Geotechnical Investigation

Proposed Residential Development

4386 Rideau Valley Drive
Ottawa, Ontario

**re: Geotechnical Response to City Comments
Proposed Residential Development
4386 Rideau Valley Drive, Ottawa, Ontario**

Figure 3 - Section A - Existing Conditions - Seismic Loading

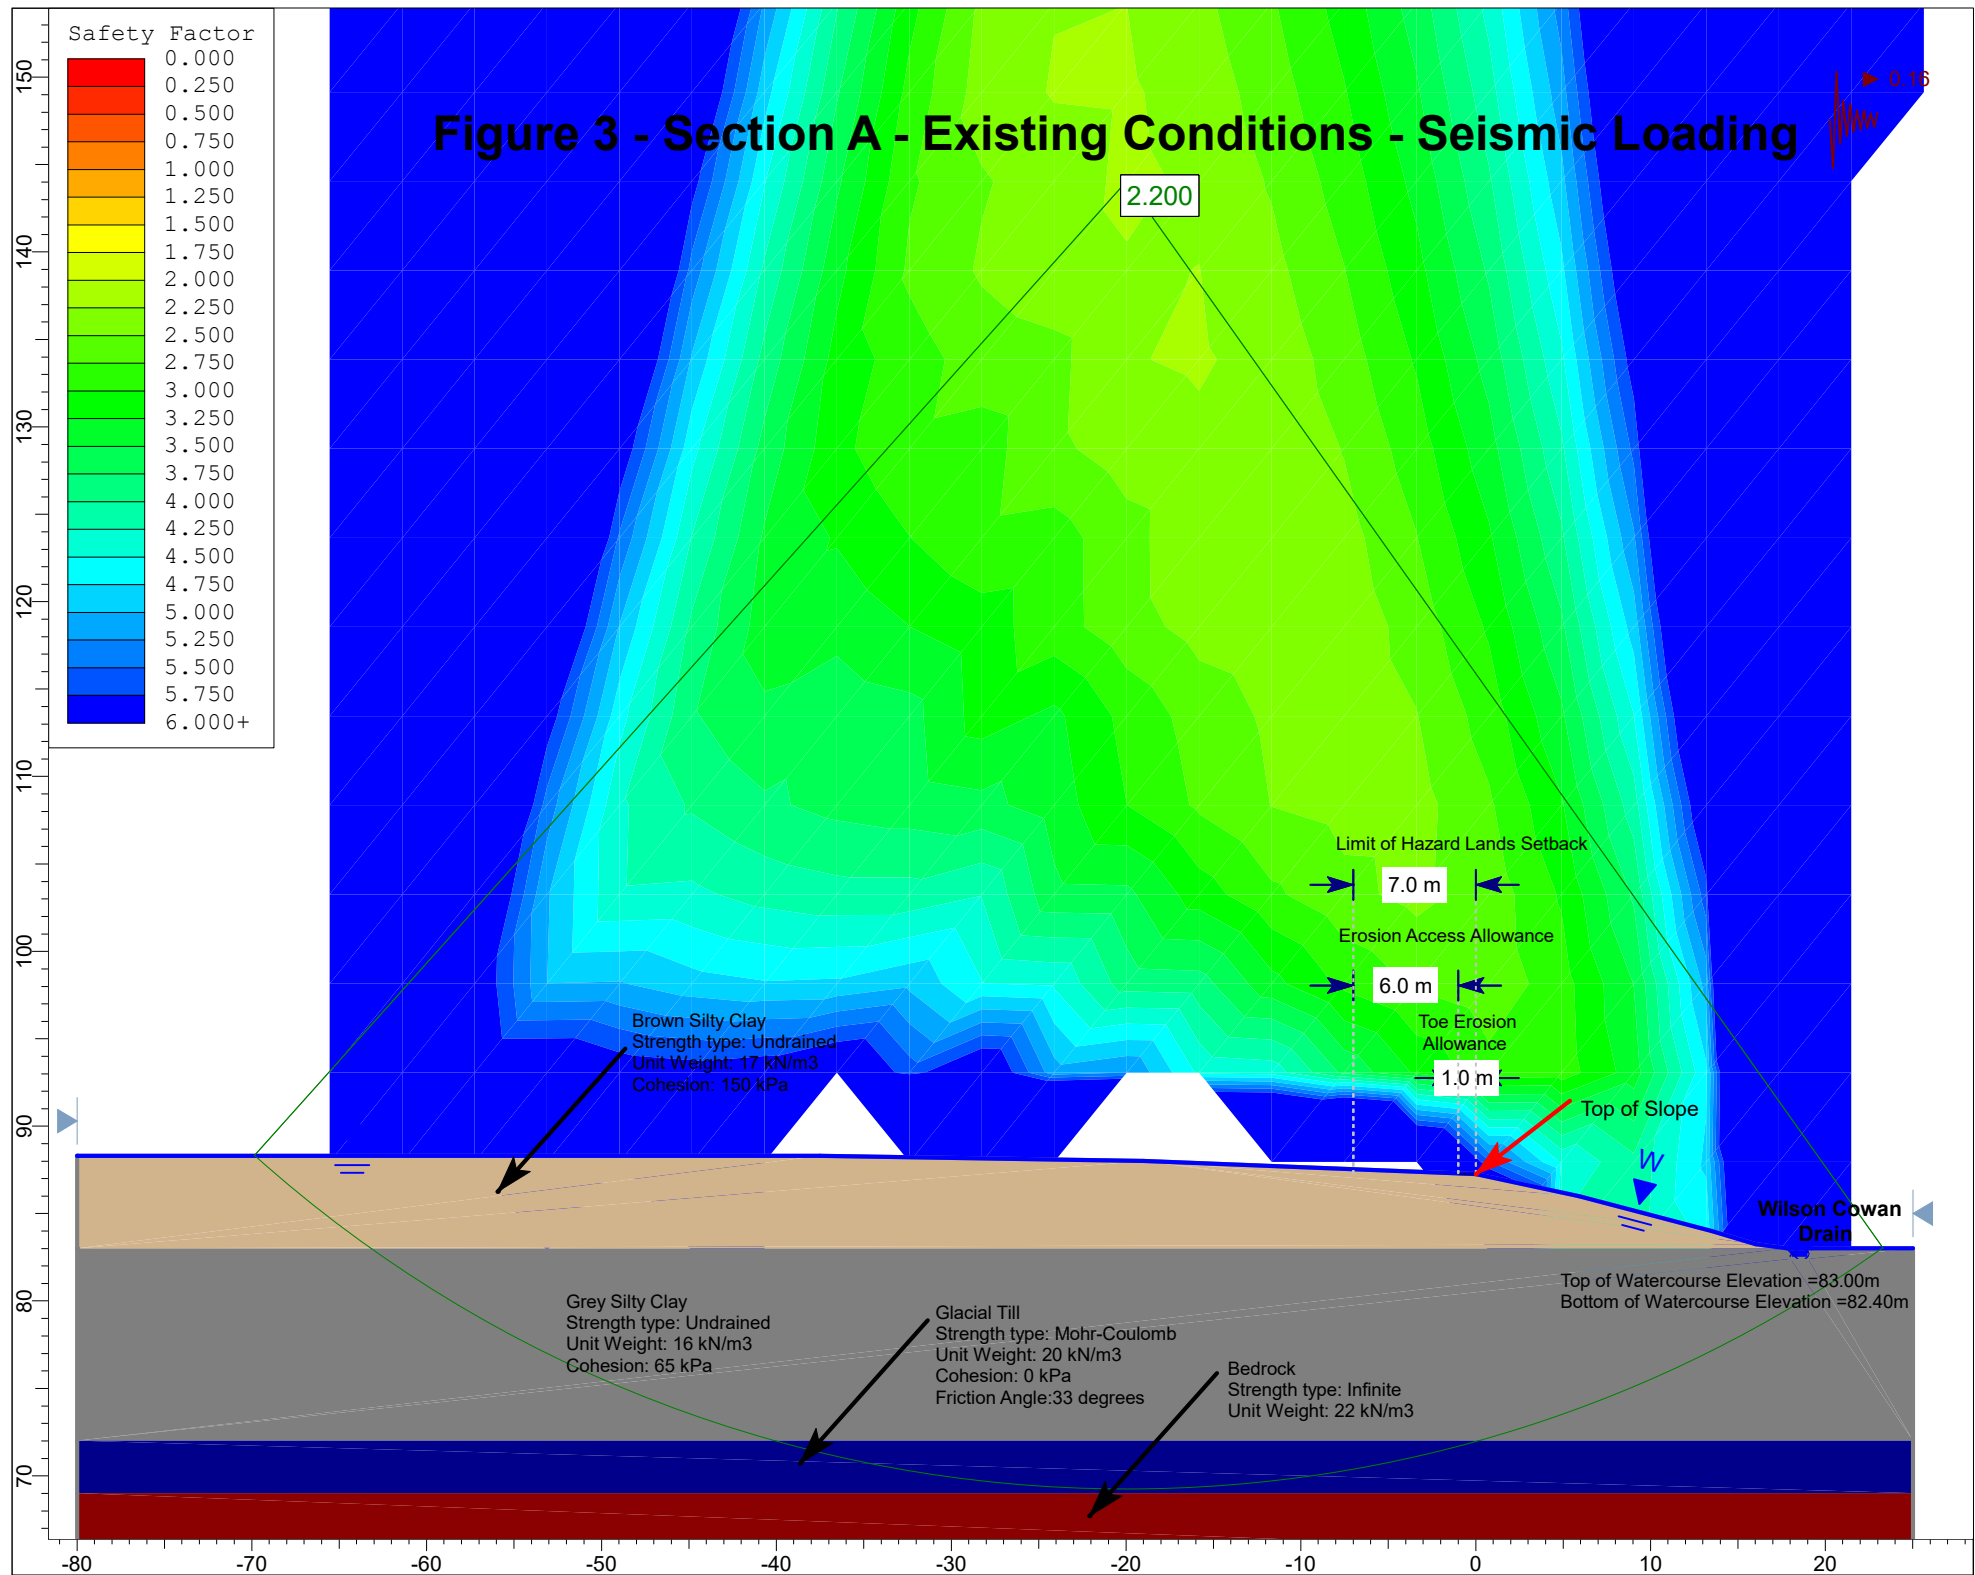
The soil annotations on Figure 3 appear to be floating.

Noted. The annotations for soil layers in Figure 3 have been modified in the above-mentioned revised report.

Figure 4 - Section B - Existing Conditions - Static Loading

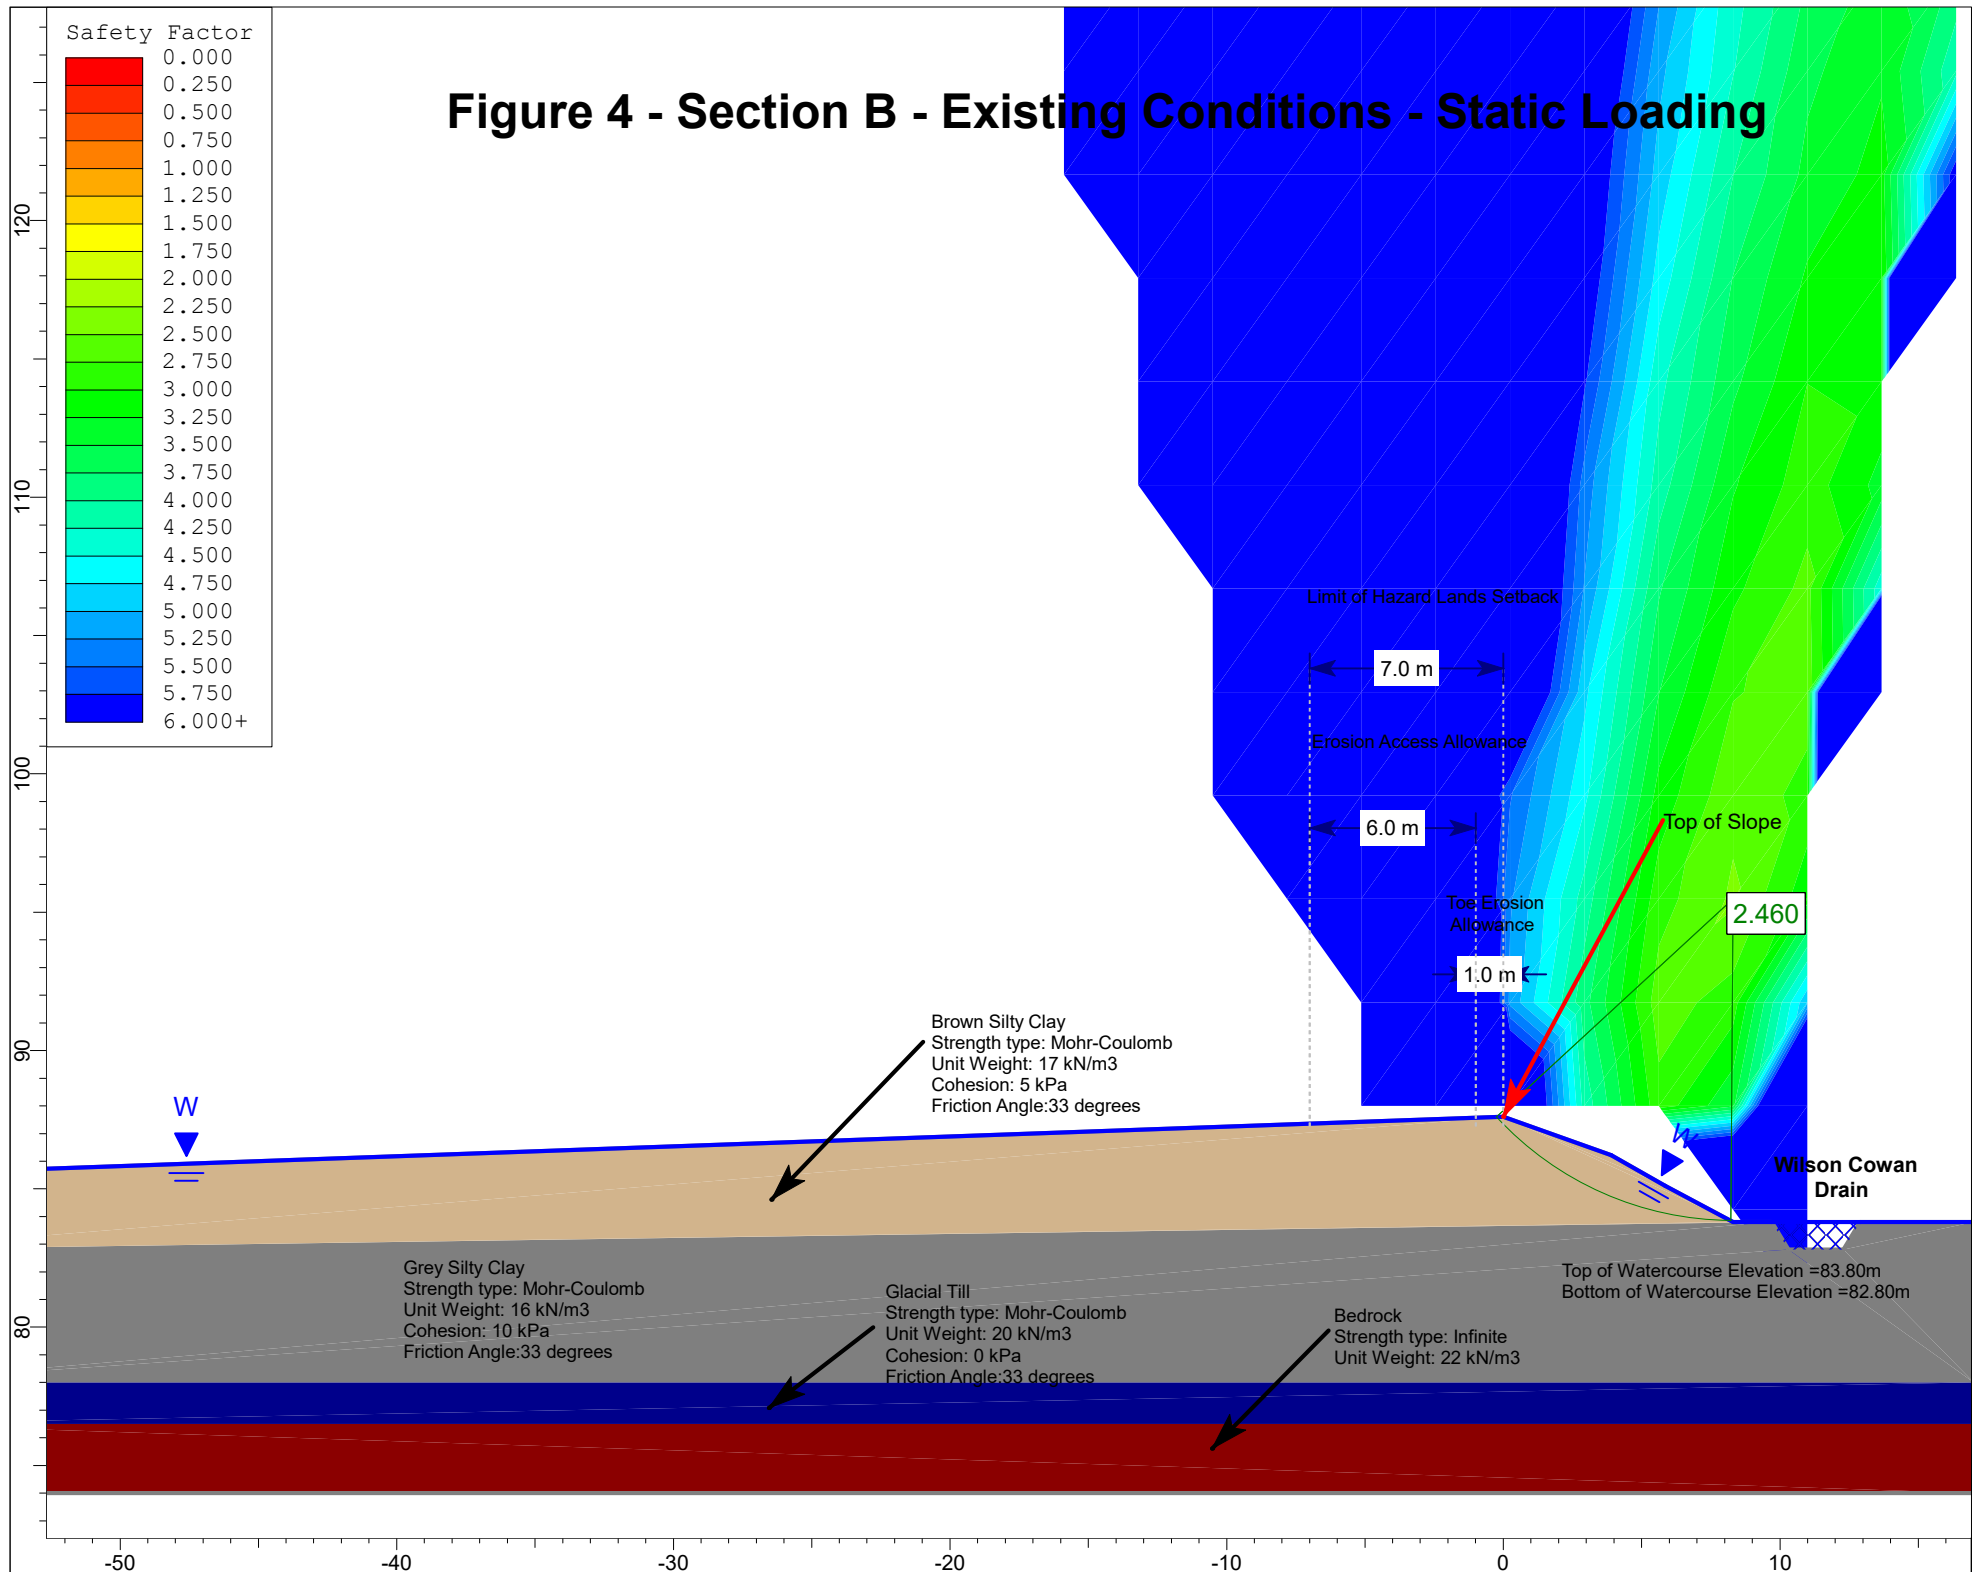
Please include bathymetric survey data used for Figure 4 (amongst others).

The bottom elevations of the watercourses at the studied cross sections has been determined using a high precision GPS, during our site visit to review the slope conditions. These elevations have been added to the slope cross sections included in the revised geotechnical report referenced above.
